In the Matter of)	
)	Docket 50-344
PORTLAND GENERAL ELECTRIC COMPANY,)	
et al)	(Control Building Proceeding)
)	
(Trojan Nuclear Plant))

I hereby certify that on July 10, 1979, Licensee's letter to the Director of Nuclear Reactor Regulation dated July 10, 1979 and an attachment entitled "Request for Additional Information, Trojan Nuclear Plant, Proposed Control Building Design", have been served upon the persons listed below by depositing copies thereof in the United States mail with proper postage affixed for first class mail.

Trojan Nuclear Plant
Docket 50-344
License NPF-1

Enclosed are the answers prepared by Bechtel Power Corporation to the remaining five questions from your letter of May 18, 1979. This submittal answers the last of the formal questions posed by your staff. A revision to PGE-1020 covering updated information will be issued shortly.

Figure 46-4 Secant Modulus, Specimen A-4

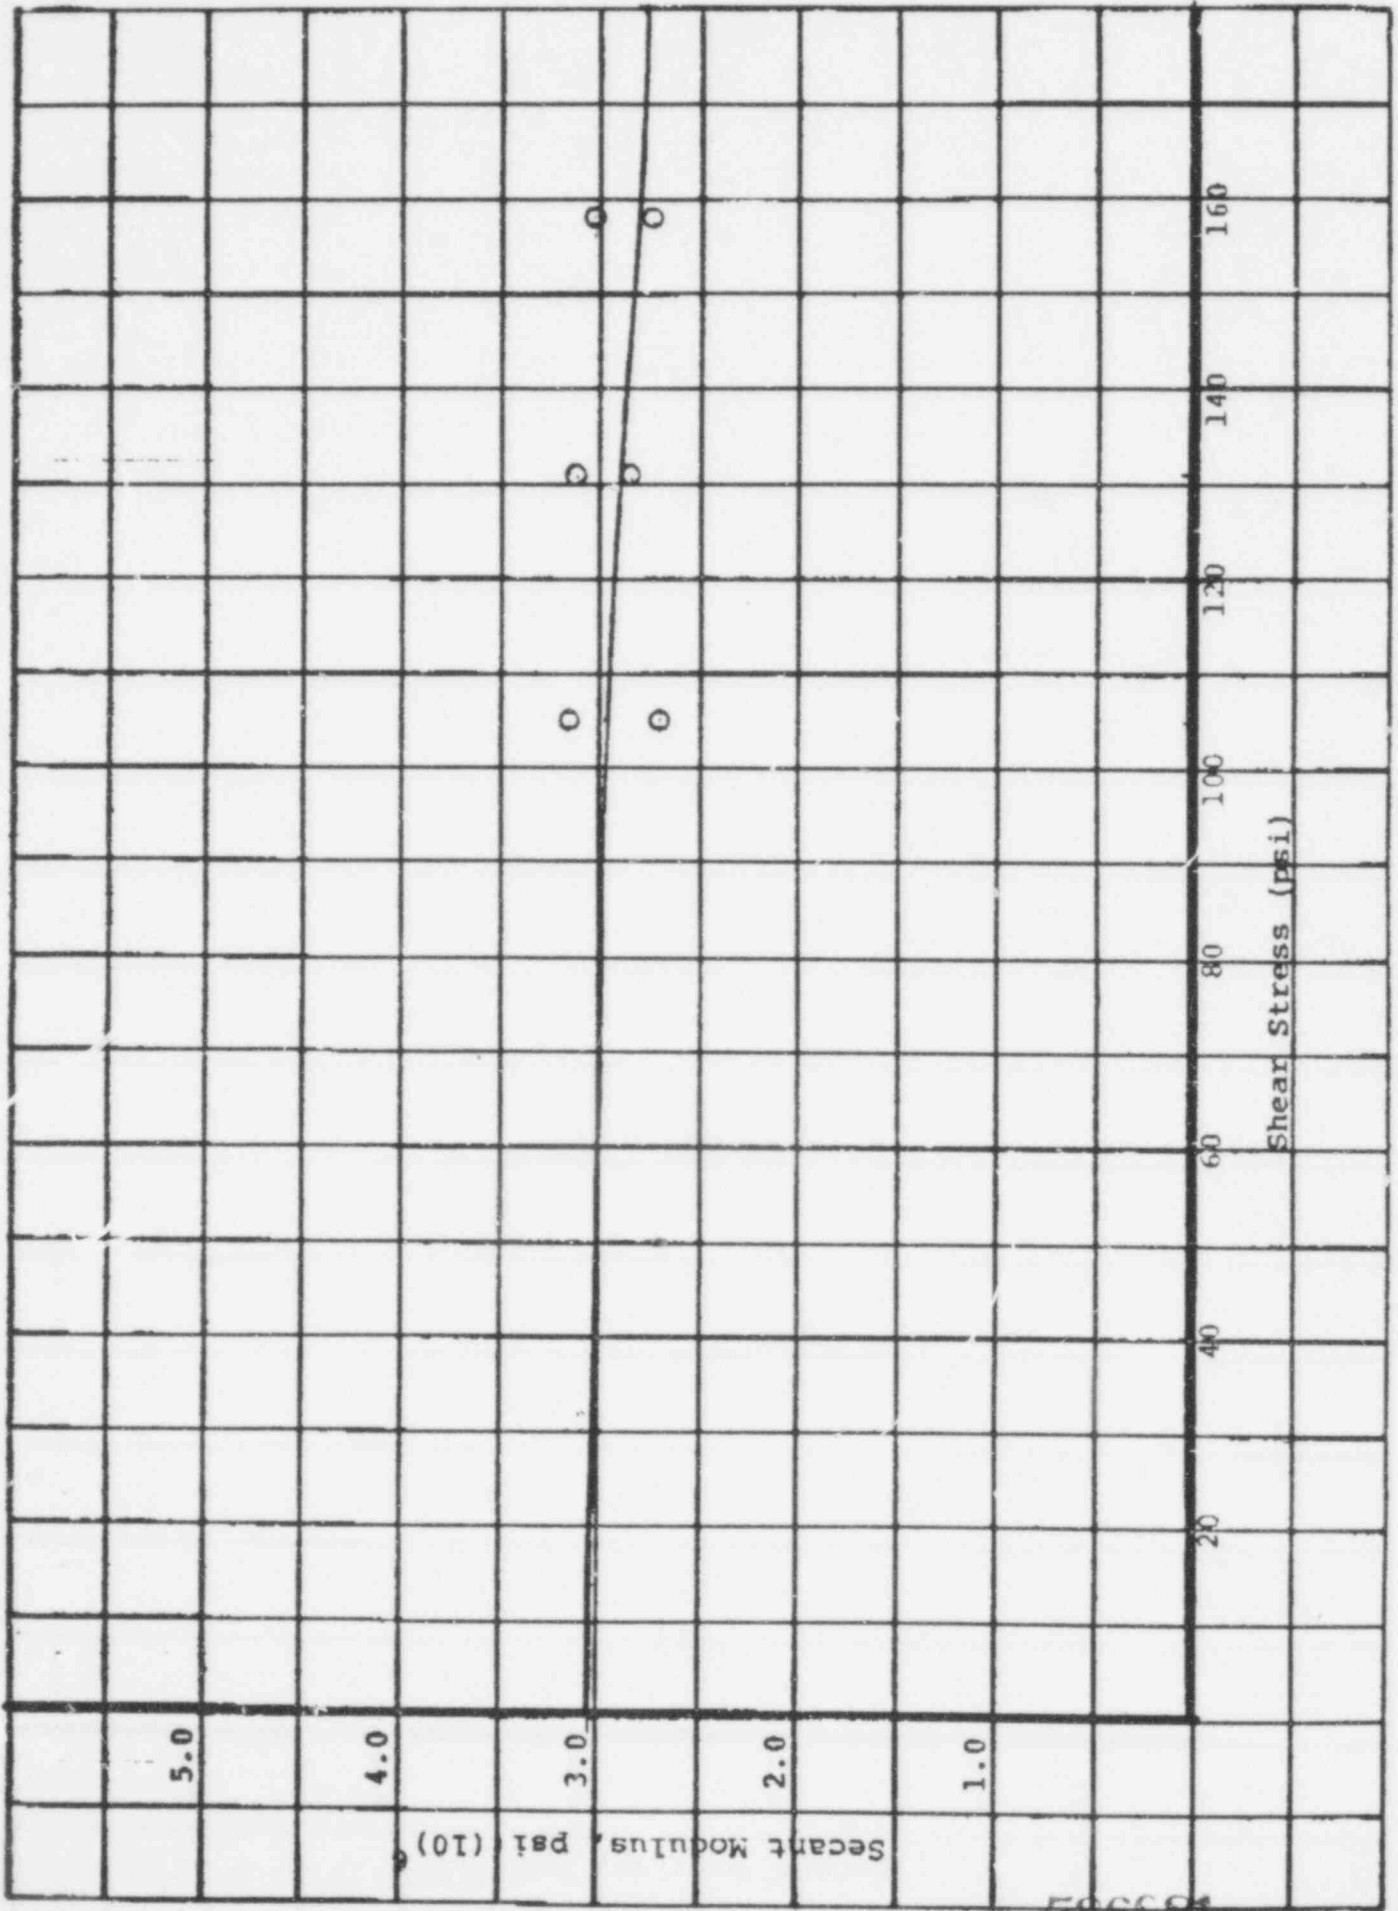
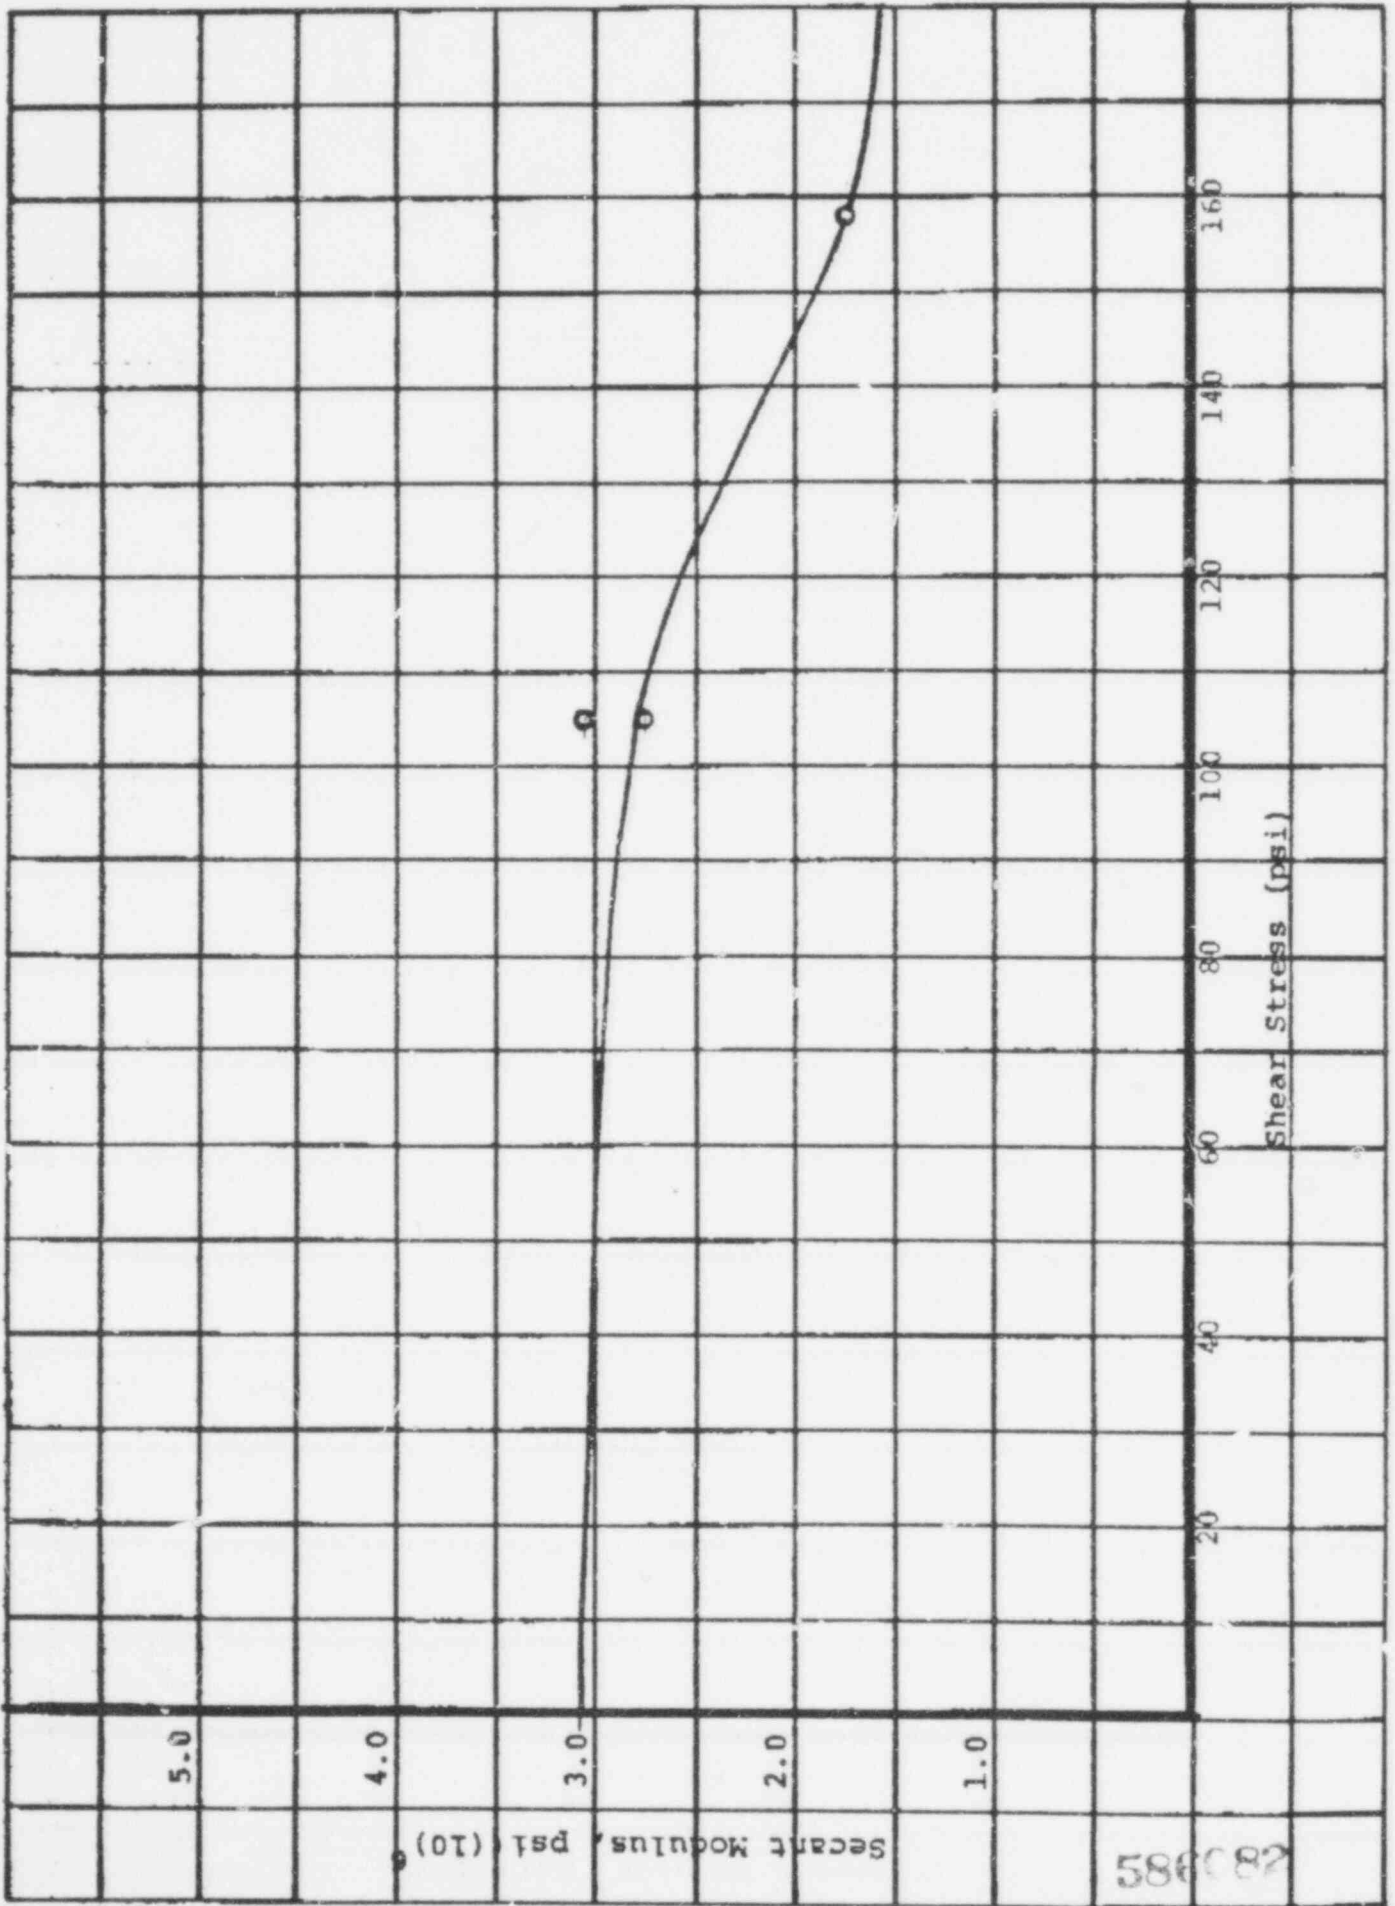
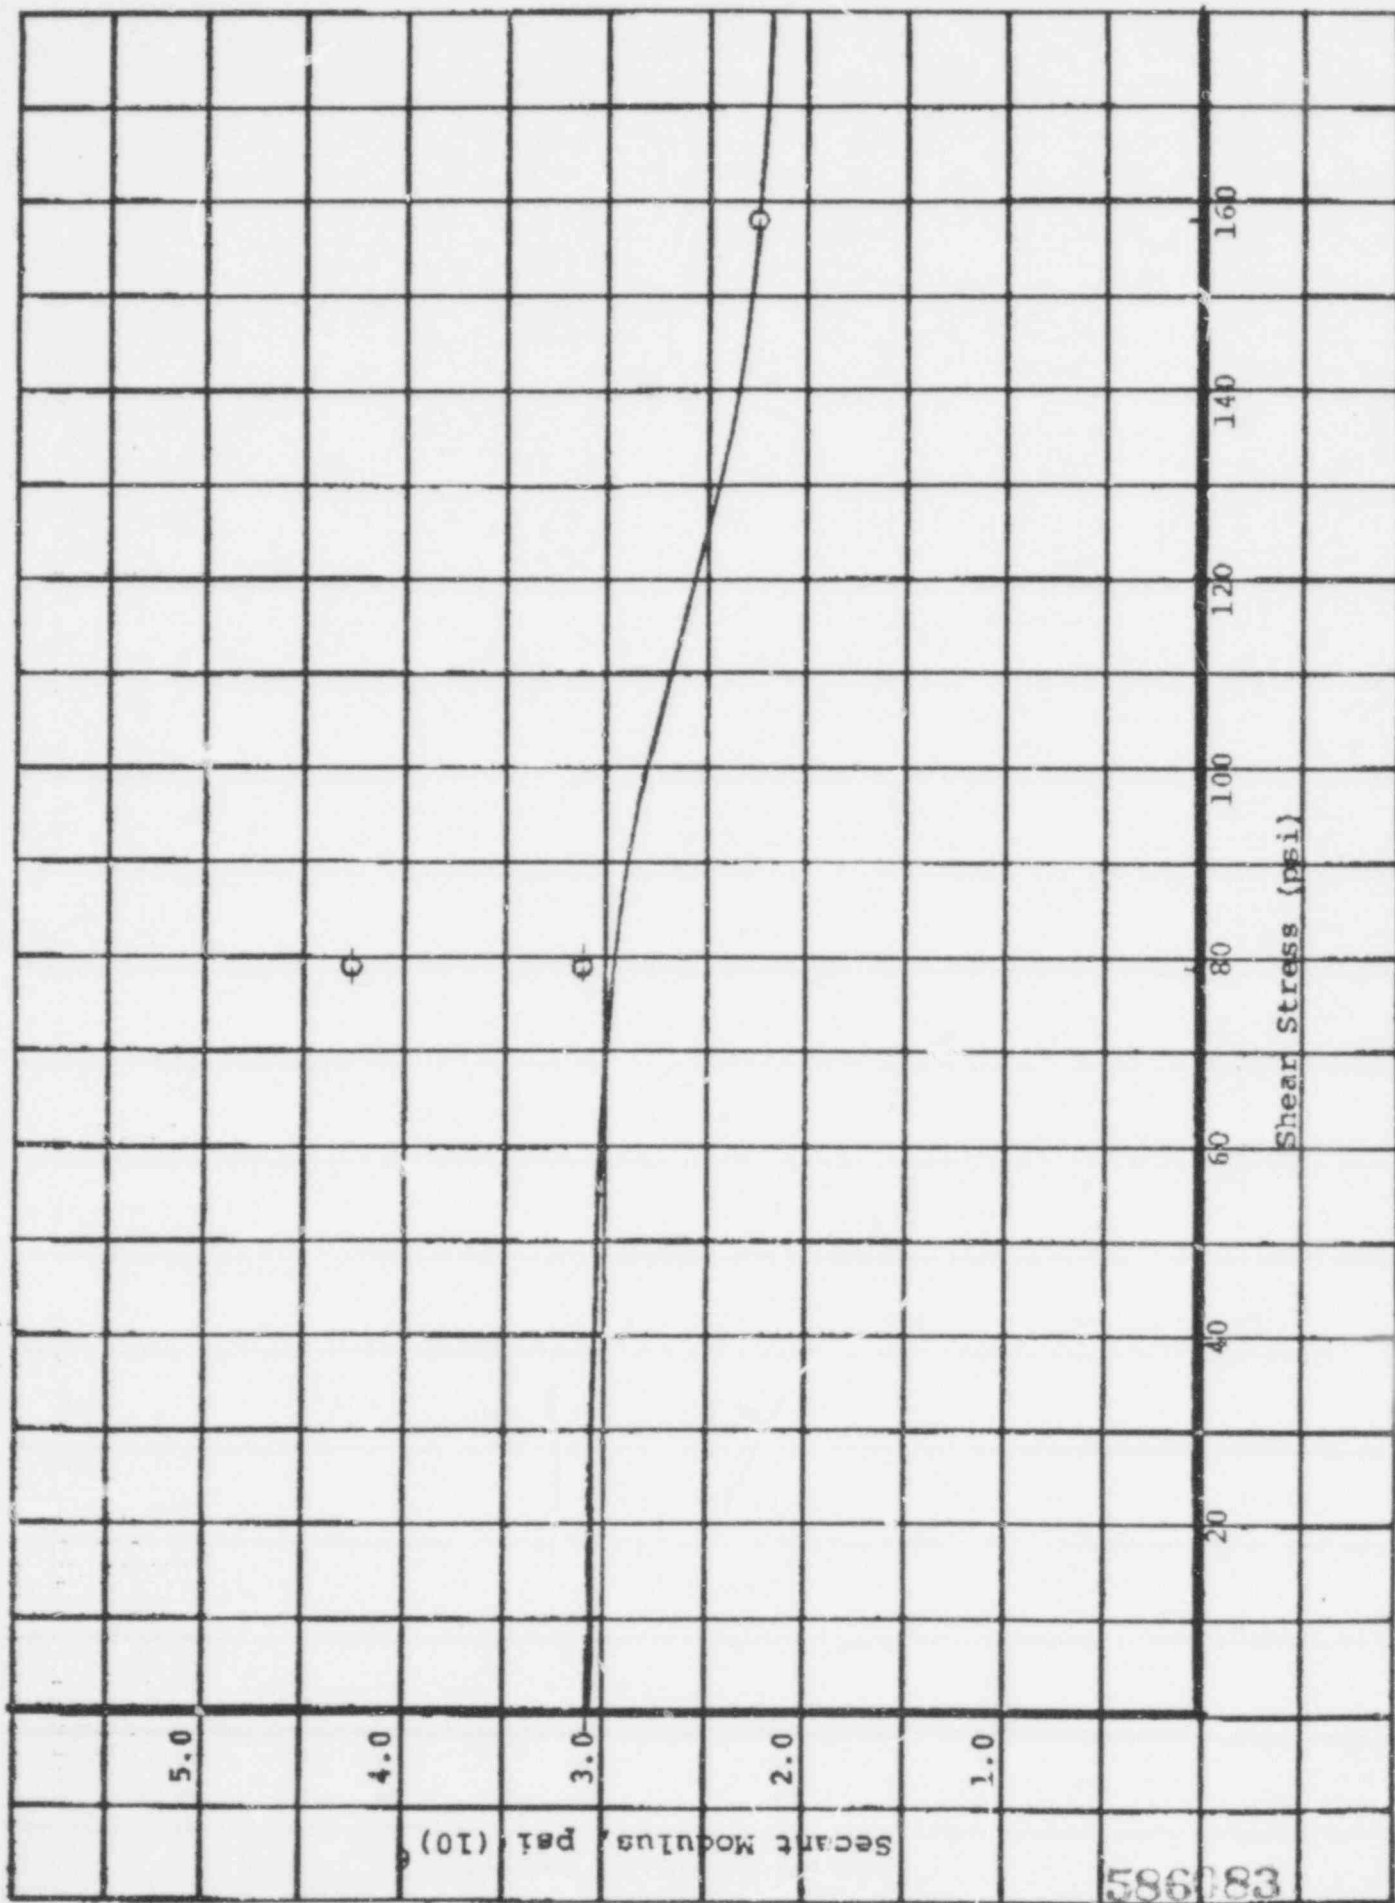
Provide the secant modulus derived for each of the test specimens vs. stress level; a comparison of the experimental initial elastic modulus for the test specimens vs. that calculated using the formula in Section 2.2.1.3.2 of Appendix B; the error bands, and their deviation, for the curves representing stiffness reduction as a function of stress level; and the stresses in each of the walls resulting from incorporation of the stiffness reduction factors in the STARDYNE model along with the associated stiffness reduction factors assumed in the analysis.

The secant modulus vs. shear stress for the test specimens is shown in Figures 46-1 through 46-20. A comparison between the experimental initial elastic modulus and that calculated using the formula in Section 2.2.1.3.2 of PGE-1020, Appendix B cannot be made since the initial modulus cannot be determined experimentally. The instrumentation was not sufficiently sensitive to measure the small deflections required for the calculation. Deflections need to be measured reliably to the nearest .0002 inch at the early stages of deformation. During this stage, the test specimen and load frame is settling in, play in instrumentation is being taken up, etc. Care was taken to minimize these effects but all could not be completely eliminated since the movements being considered are between 1 and 10 times smaller than the thickness of this paper. Some difficulty was even encountered at the first load step but for the other load steps the deflections were

large enough so that effects were not important. As shown in Figures 46-1 to 46-20, there are in general two data points at the first load step. The top part is obtained from the average deflections recorded on each side of the specimen and the other is obtained from the most active dial gauge. The initial modulus used in the plot was calculated using the equation in PGE-1020, Appendix B. An error analysis of the data could not be made since there are not enough specimens with duplicate conditions to provide sufficient data base. The effect of variation is considered in the broadening of the response spectra.
